Interactive comment on “Technical note: Water table mapping accounting for river-aquifer connectivity and human pressure” by Mathias Maillot et al.

Mathias Maillot et al.

Received and published: 21 August 2019

Fig. 1. Fig. a: Water table level compared to topographic level at LWC sampling points. The red symbols correspond to the samples affected by the pumping wells, the black symbols correspond to the unaffected

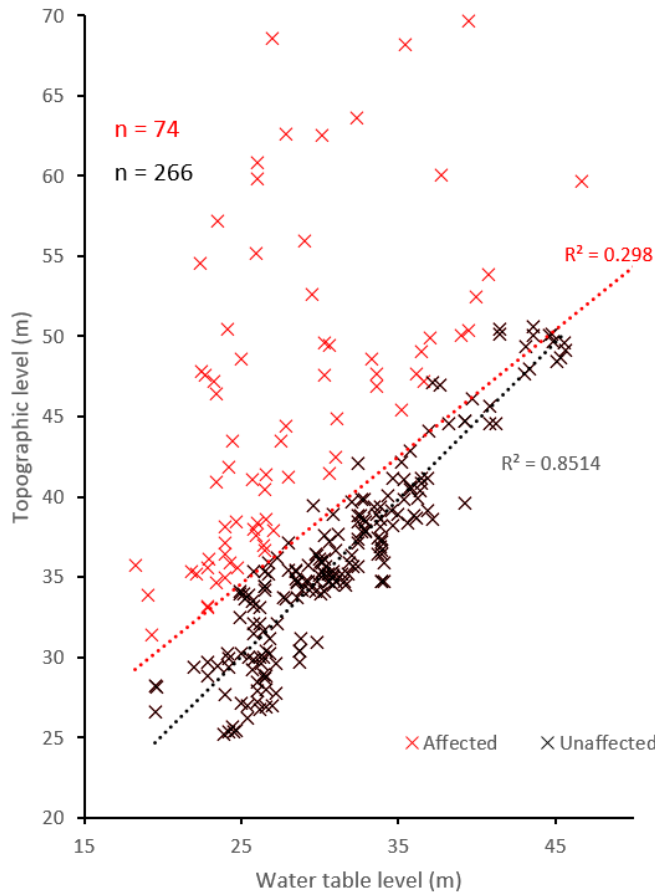
P4 L18-29: This part is still very much unclear. First of all, there should be a conceptual discussion about the effect of pumping. Namely, it must be recognized that the effect of pumping is not only punctual. Hence, nowhere will the water table be really natural/unaffected. In this view, it is not even clear why any data should be removed. Secondly, you write that the location of pumping wells is required. Do you have these data? It seems not, otherwise you would not need to use a threshold value on UZD. But this should be said! Thirdly, a rationale for the employed 10 m threshold is still lacking. Fourthly, you write that the variographic studies are performed on the second category of data. Does this mean that the rest of the analysis uses all the data from both categories?

Some justifications were added P5 L3-7 to explain the identification of affected piezometers. The Dupuit-Forchheimer assumption is not valid within the capture zone of a pumping well. Therefore, the head is not hydrostatic (Grubbs et al., 1993), the piezometric value and the topography are not correlated within its capture zone. We noted that there is no correlation between the piezometric value and the topography for the locations where UZD exceeds 10 m (Fig.a). Without the exact knowledge of pumping wells location, we assume that these samples are located within the pumping wells capture zone. Indeed, this differentiation was only used to construct the experimental

variograms to which the variogram model are fitted. The rest of the analysis uses all the data from both categories.
